HUNTS POINT INTERSTATE ACCESS IMPROVEMENT PROJECT – CONTRACT 3

PIN X731.65, Contract D900055

Addendum #8

July 22, 2022

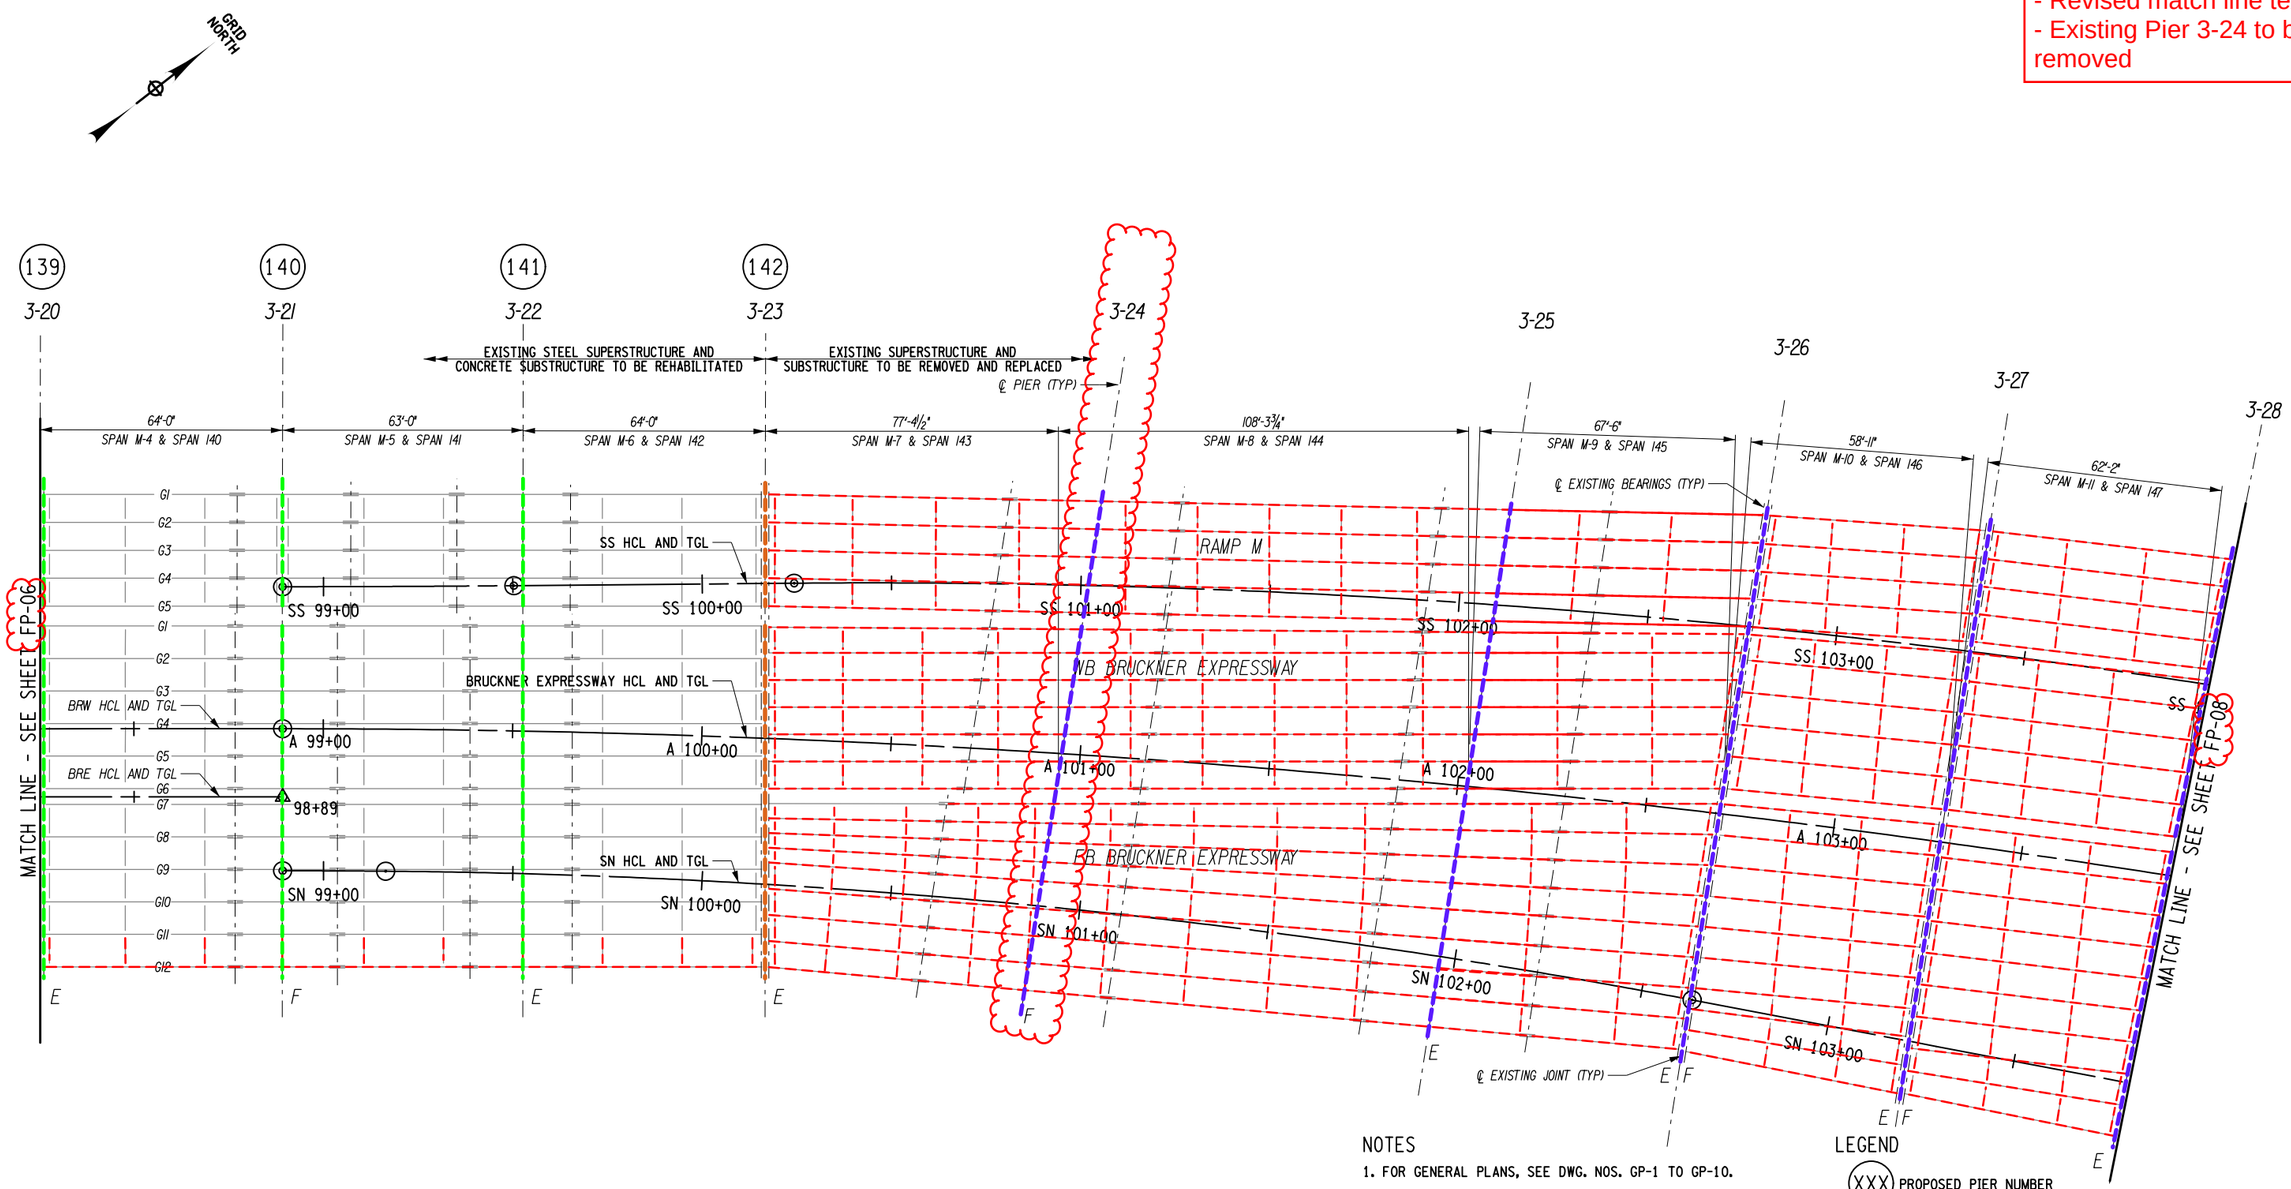
Revisions for Addendum 8:
- Revised match line text
- Existing Pier 3-24 to be removed

EXISTING FRAMING PLAN

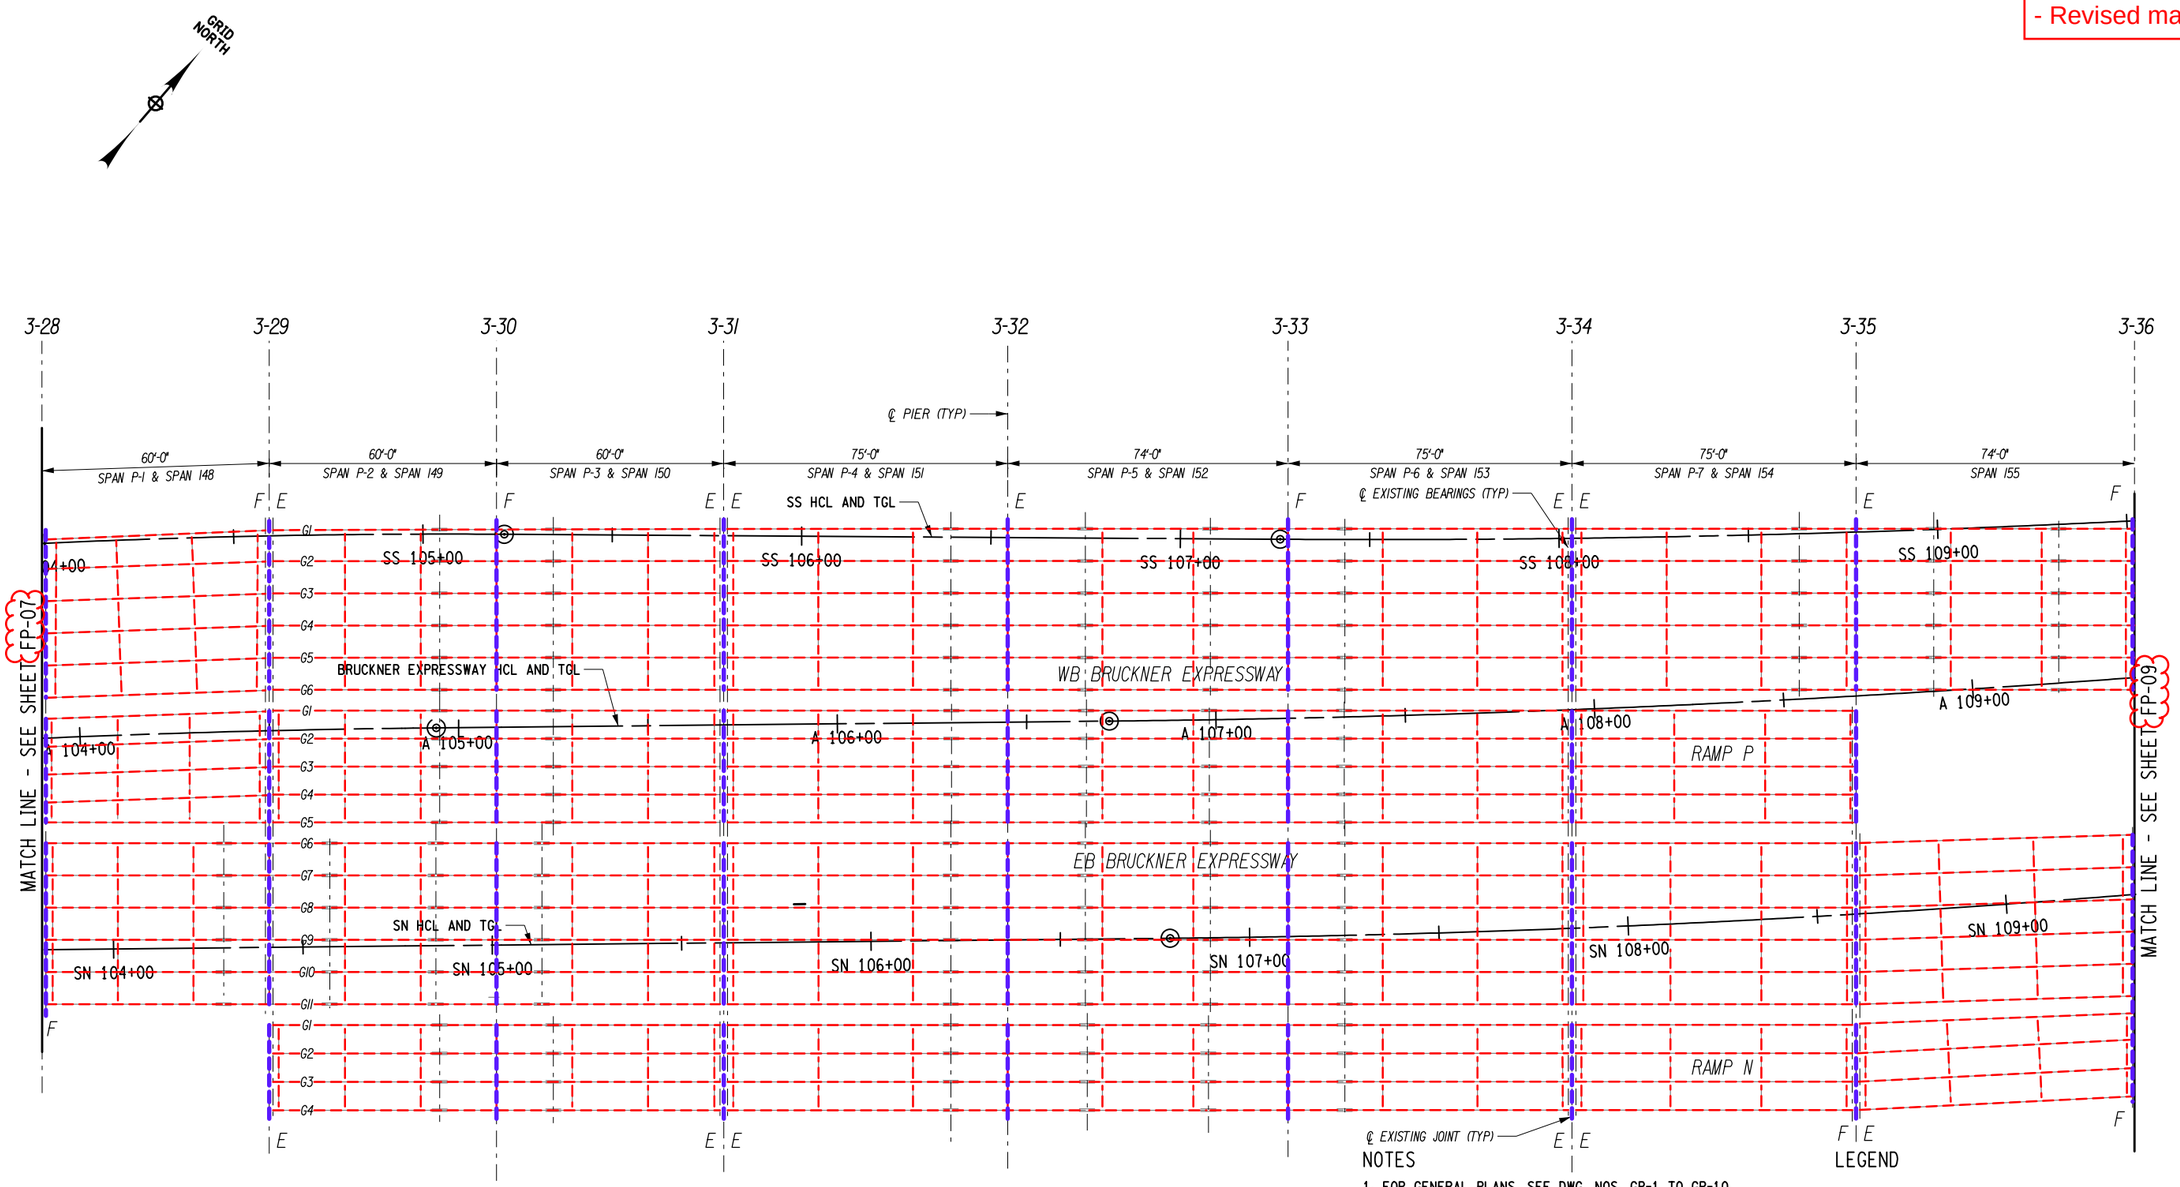
Revisions for Addendum 8:
- Revised match line text

EXISTING FRAMING PLAN

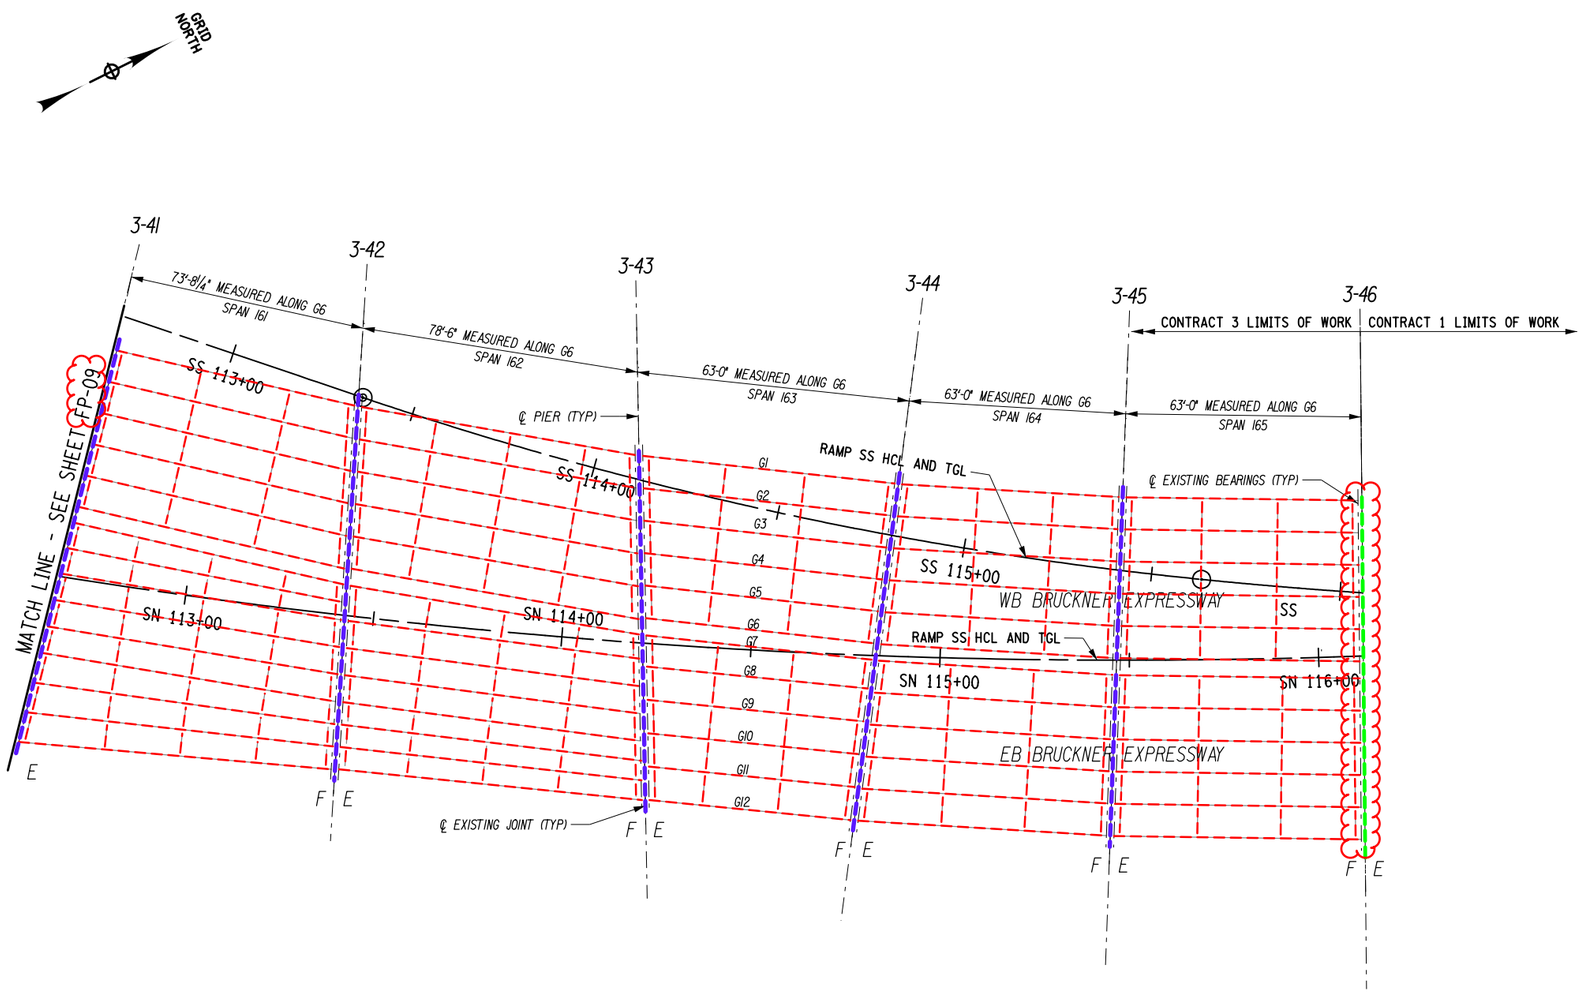
Revisions for Addendum 8:
- Revised match line text
- Existing pier 3-46 to be rehabilitated
